COMMITTEE OF ADJUSTMENT

MINOR VARIANCE REPORT

APPLICATION: CAV A/055/2024

CAV A/055/2024 – 1126 Westview Terrace (West District) (OP Designation: Medium Density Residential)

MAIN FLOOR PLAN
PRIVATE RESIDENCE
1126 WESTVIEW TERRACE

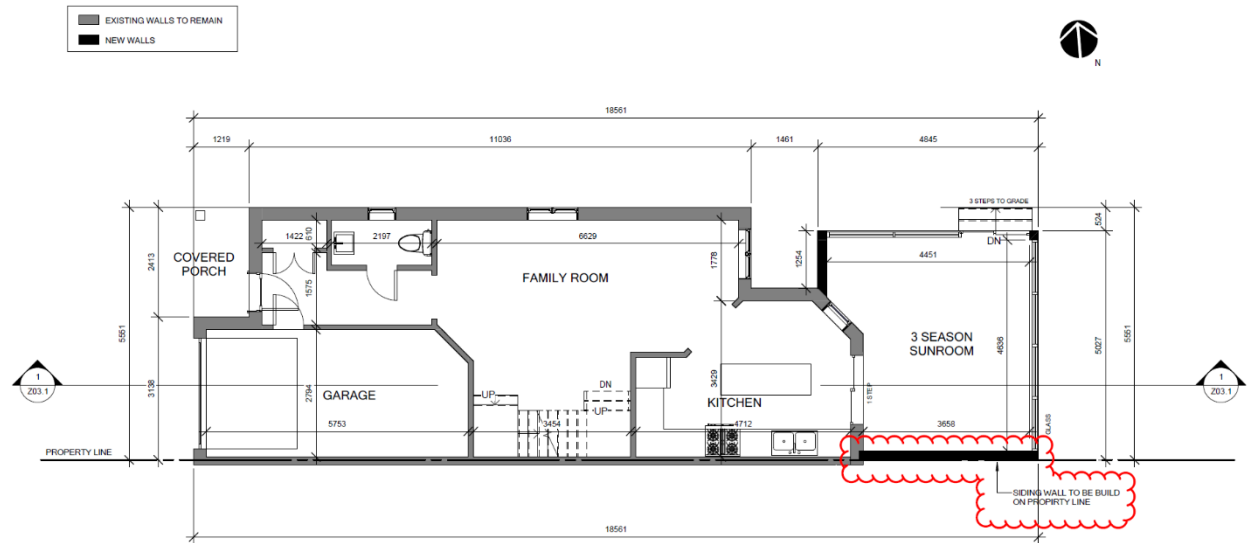
Based on the application as submitted, the applicant is proposing to construct the rear addition following the townhouse partition wall on the property line:

Staff are of the opinion that without an appropriate setback provided along the southerly interior side yard for the proposed addition, the proposal does not maintain the general intent and purpose of the Livable Oakville Plan or implement the Urban Design Guidelines for Stable Residential Communities.

SITE PLAN
PRIVATE RESIDENCE
1126 WESTVIEW TERRACE

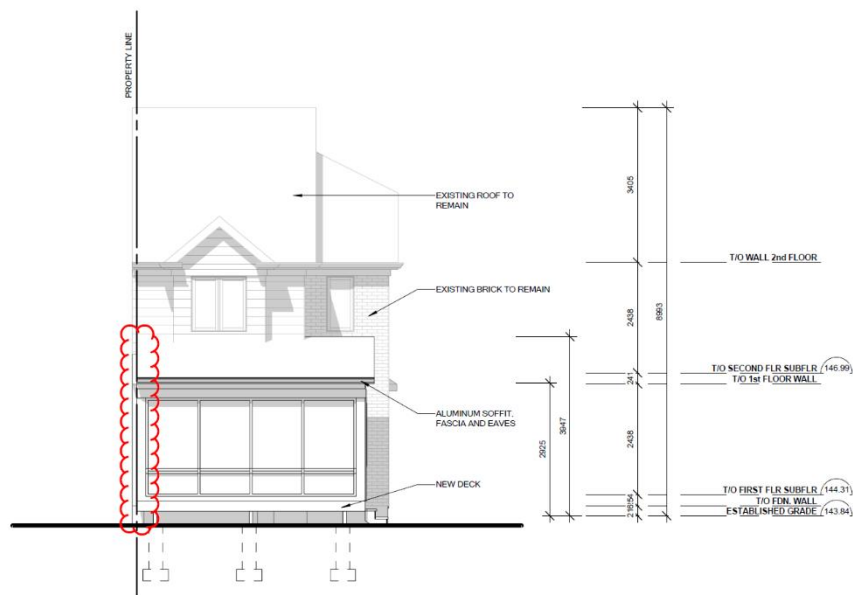
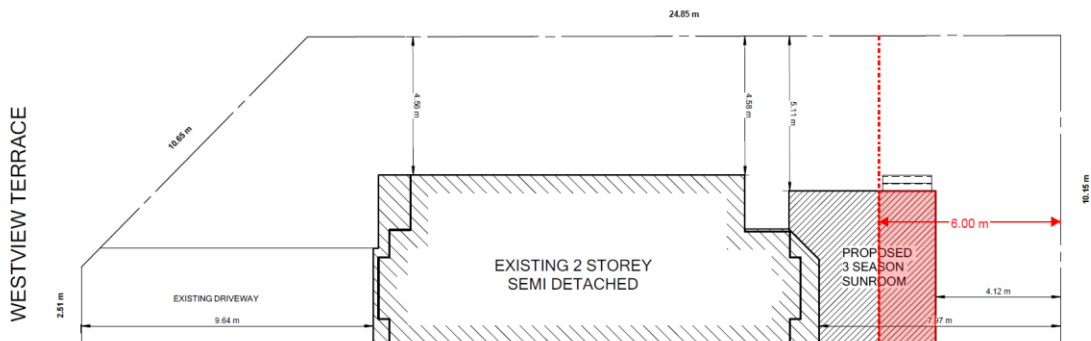
The intent of regulating the rear yard setback is to ensure appropriate separation of dwellings and provide rear yard amenity space. The subject property is an end unit of a townhouse block, and accordingly has a demising wall shared with the unit to the south with a 0.0 m setback. It is

noted that the Zoning By-law permits accessory buildings in the rear yard however, a minimum 0.6 m setback to a rear or interior side yard.

Based on a site inspection and observation of rear yard amenity spaces in the surrounding neighbourhood (consisting of other townhomes), decks and patios are commonly found in rear yard amenity areas with landscaped green space. However, staff did not observe any rear yard additions similar to the proposed sunroom. The proposed location of the sunroom in the rear yard, with a 0.0 m interior side yard setback has potential impacts on the abutting property to the south. This would result in no access for construction, maintenance or repairs along the southerly side yard based on the submitted materials:

Staff are of the opinion that the location of the addition in the rear yard, including the 0.0 m setback provided along the southerly interior side yard does not maintain the general intent and purpose of the Zoning By-law.

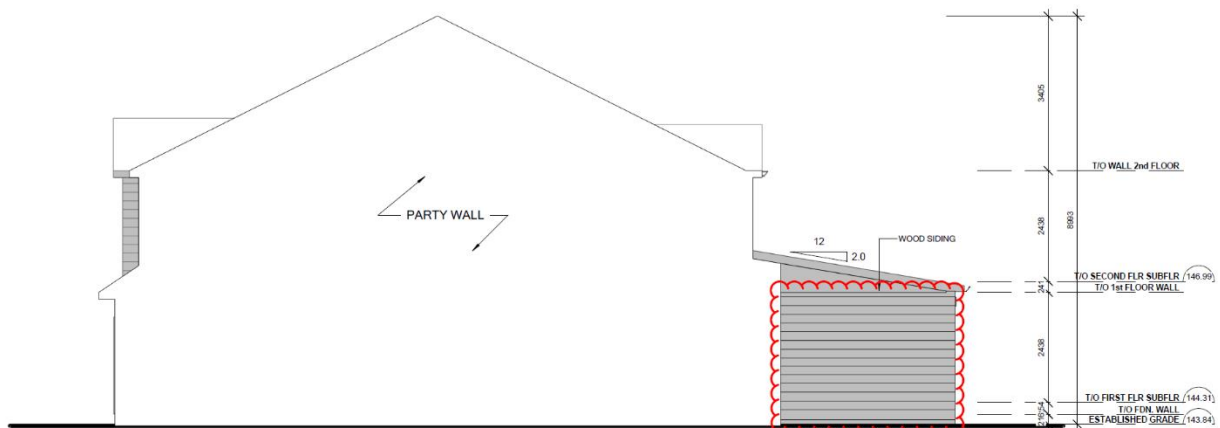
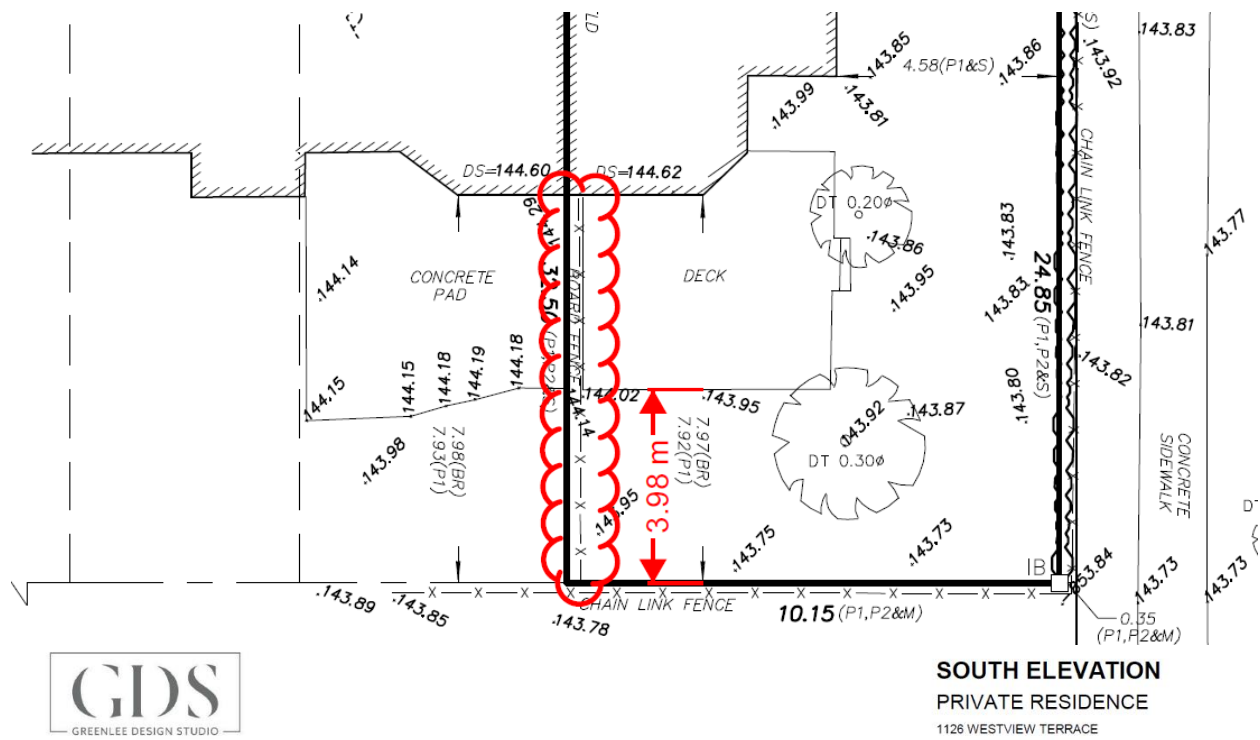
Based on the materials submitted further to the comments above, Staff also observed that the existing fence located between the neighbours rear yard amenity area is located wholly on the subject lands:

As seen above, the addition is proposed to be built on the property line and it is not clear if the existing fence will be relocated, replaced or removed. Furthermore, Staff are not aware of any agreements between the owner and abutting neighbour to provide access for construction, maintenance or repairs as previously mentioned. There are also no details in the submitted

materials as to how drainage and grading will be managed along the shared property line, noting that any stormwater runoff or spill from rain or snow melt that runs down the wood siding of the addition would not be accessible for the owner to manage from their property.

Staff are of the opinion that the proposal does not represent an appropriate development of the subject property. The development as proposed may result in undue adverse impacts on the abutting property to the south and could pose a concern within the existing neighbourhood related to other existing townhomes in the area and their rear yard amenity spaces.
